Meeting Summary

Lacy Road

Fitchburg Community Center to S. Syene Road

To:	East Fitchburg Neighborhood Association
From:	Cory Horton, P.E., Director of Public Works/City Engineer
Date:	January 7, 2016
Subject:	Lacy Road Design Update

DESIRABLE TERRACE FOR RUNNING LENGTH

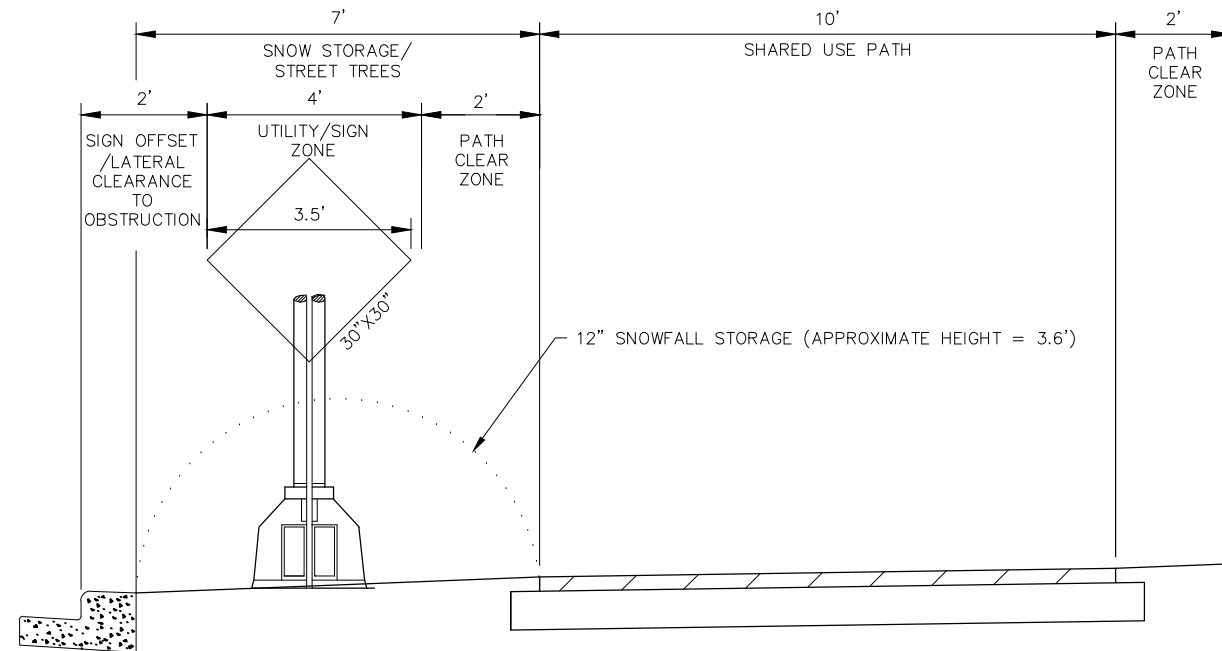
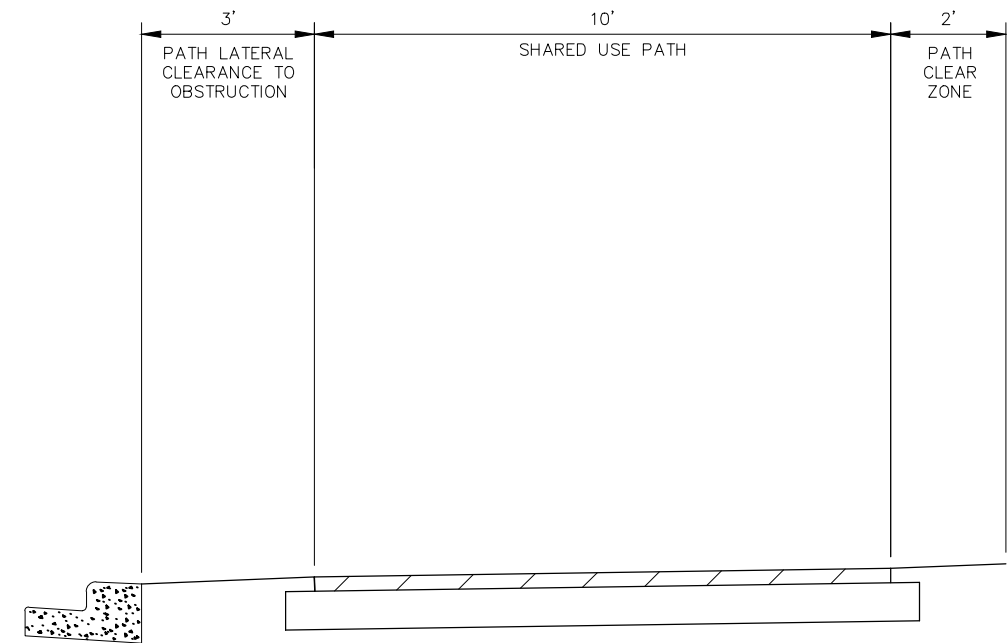
3. Minimum terrace width discussion
 - a. Troy reviewed the desirable terrace width for running length along Lacy Road to be a minimum of 7.0'. Items discussed at the December 17 meeting were restated.

- b. Ahna commented that one factor that has not been identified for the terrace area is storm water treatment. Bioswales are being considered along the project to handle the storm water requirements of reducing the total suspended solids (TSS) and peak flow control. The terrace width may also be dictated by these storm water treatment needs. More evaluation needs to be completed for the storm water component of the project.

For all of the reasons stated above, it is not acceptable to construct Lacy Road with a 3' terrace between the path and the road for a continuous length along the roadway. It is necessary to maintain a 7' standard terrace with the flexibility of narrowing the terrace at isolated locations.

EVALUATION OF POTENTIAL DESIGN ADJUSTMENTS FOR TREE PRESERVATION

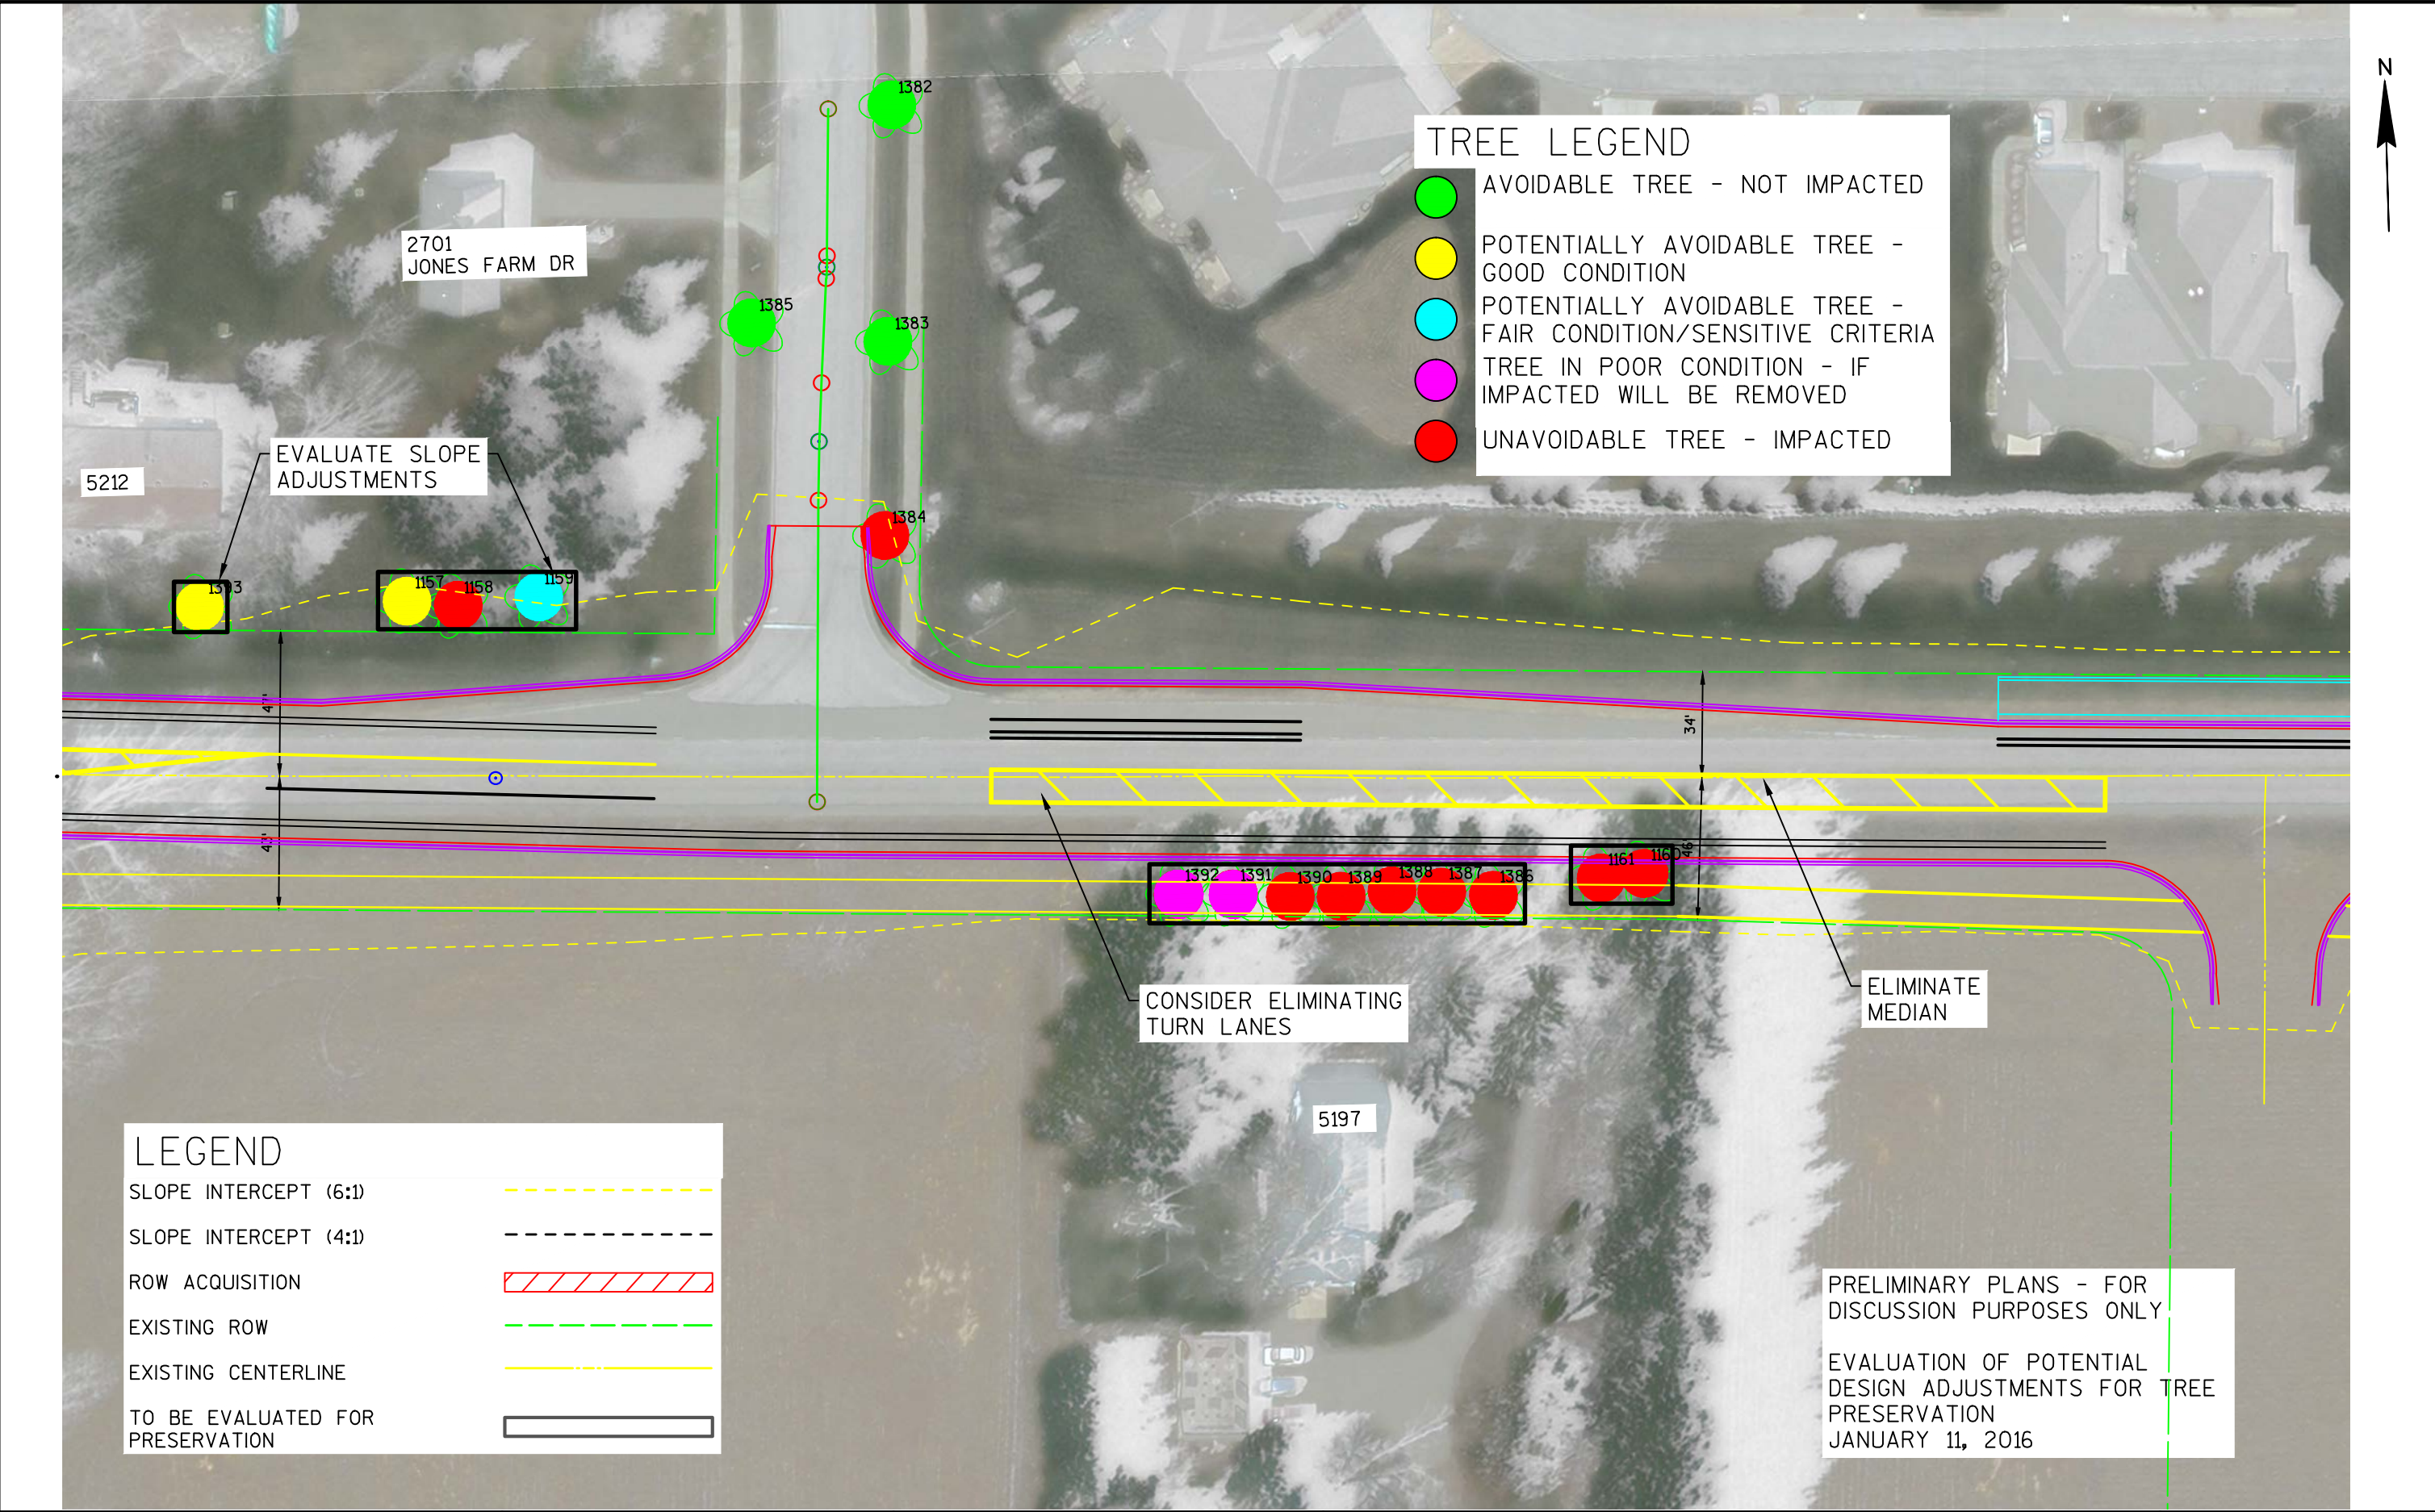
ELIMINATE MEDIAN

CONSIDER ELIMINATING
TURN LANE

- b. Ahna presented a memo which describes the proposed turn lanes at the minor intersections. Ahna stated that the median pavement that was previously shown between some of the left turn lanes will be removed. Ahna provided a discussion on the growth of traffic volume on Lacy Road over the past decade and stated that volumes are expected to continue to increase until the Nobel Drive extension is completed. The Nobel Drive extension is anticipated to detract some through traffic from Lacy Road.

PROJECT NO:5849-00-09	HWY:LACY ROAD	COUNTY:DANE	COOKE PROPERTY AVOIDANCE - JANUARY 4, 2016	
-----------------------	---------------	-------------	--	--

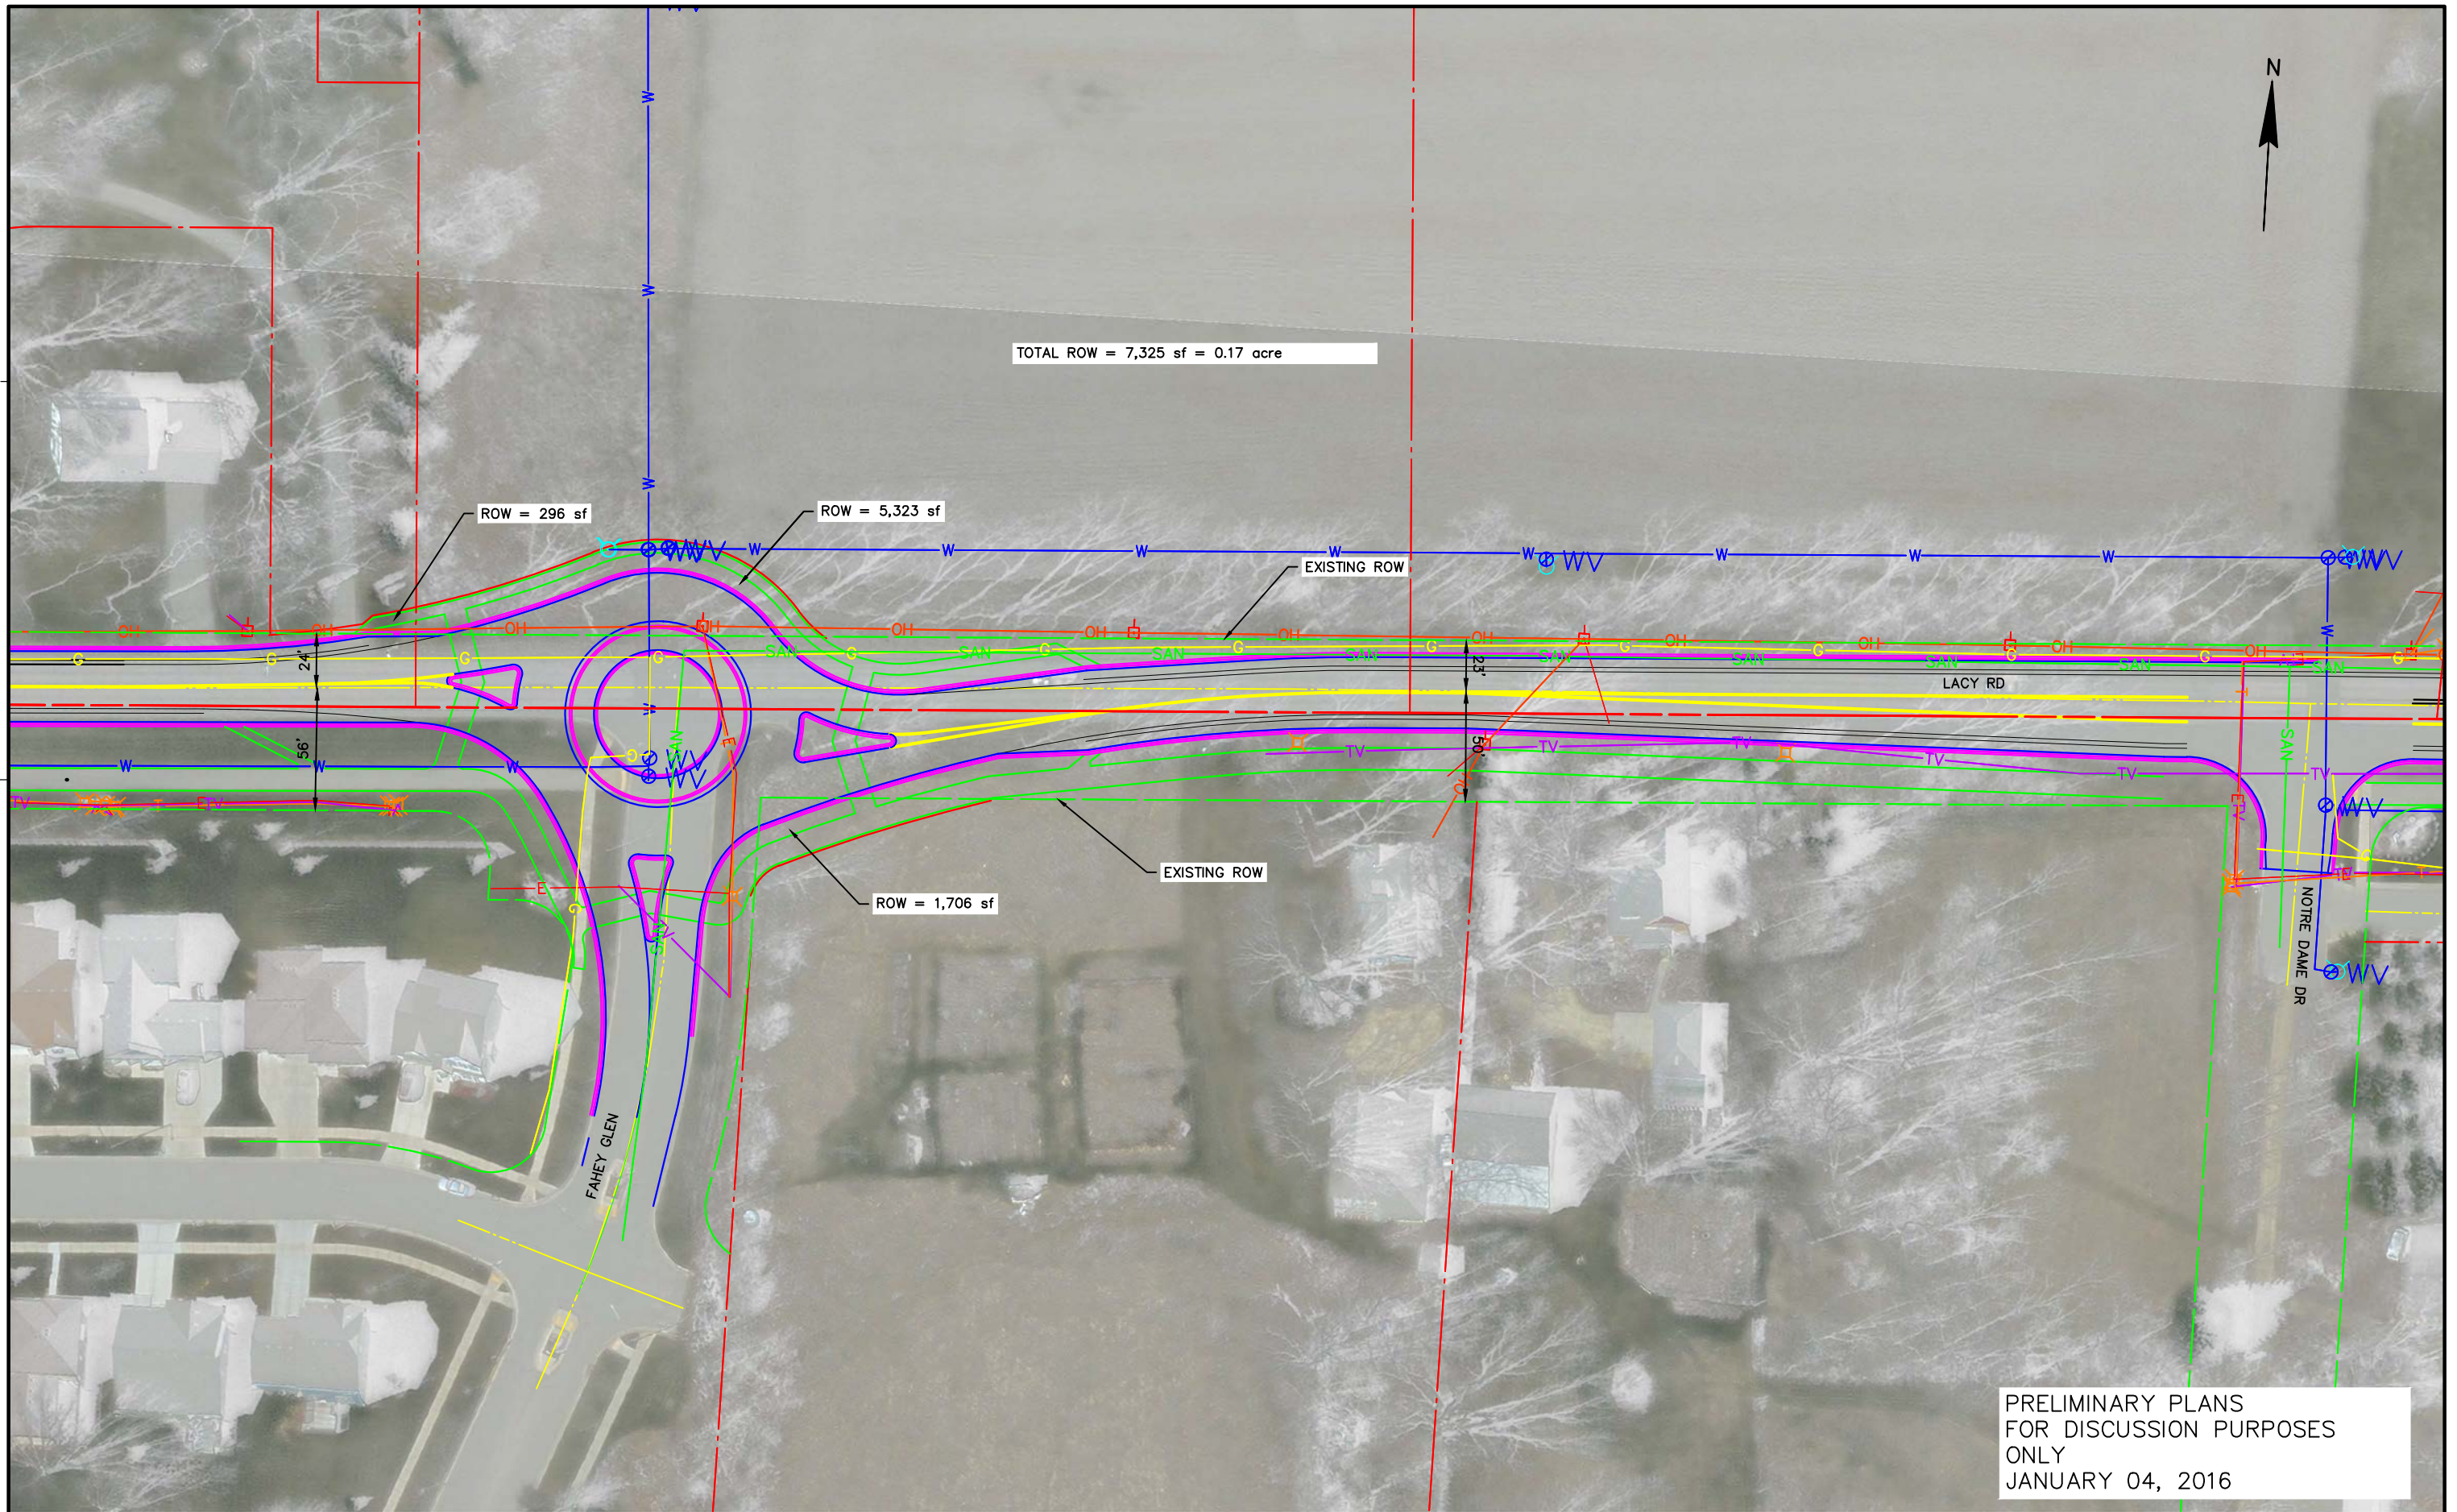
- 5. Intersection improvements
 - a. Troy provided exhibits showing a redesigned Fahey Glen roundabout intersection. The Lacy Road alignment has been shifted north along the Cooke property and the roundabout has been shifted to the west. The overall right-of-way acquisition needs at the intersection has been reduced. The committee was generally in favor of the new design.

layout/alignment be considered to address the comments and concerns received from Samuel Cooke, an adjacent property owner and member of the EFNA group. Mead & Hunt has prepared an alternate design in response to that request. Staff is supportive of the alternate layout/alignment and will present this at the January 14 EFNA meeting.
